## IOWA DEPARTMENT OF NATURAL RESOURCES LAND & WATERS BUREAU WALLACE STATE OFFICE BUILDING

LACEY-KEOSAUQUA STATE PARK CAMPGROUND IMPROVEMENTS, VAN BUREN COUNTY, IOWA PROJECT NUMBER: 17-06-89-01

Page 1 11/9/2017 ADDENDUM #2

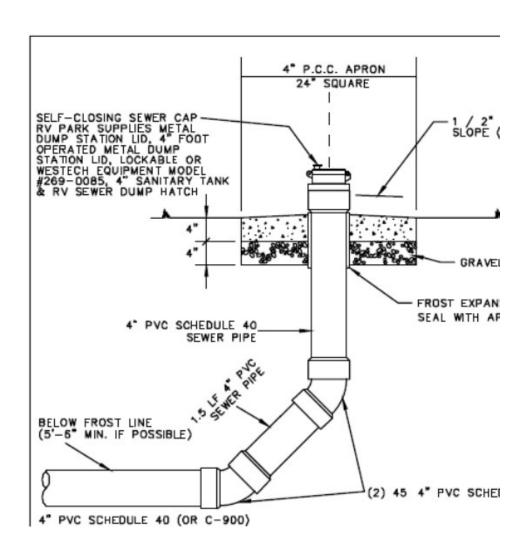
1. Replace the detail on Sheet 15 depicting the "Recreational Vehicle to Sanitary Sewer Connection" with the detail on Page 2 of this Addendum.
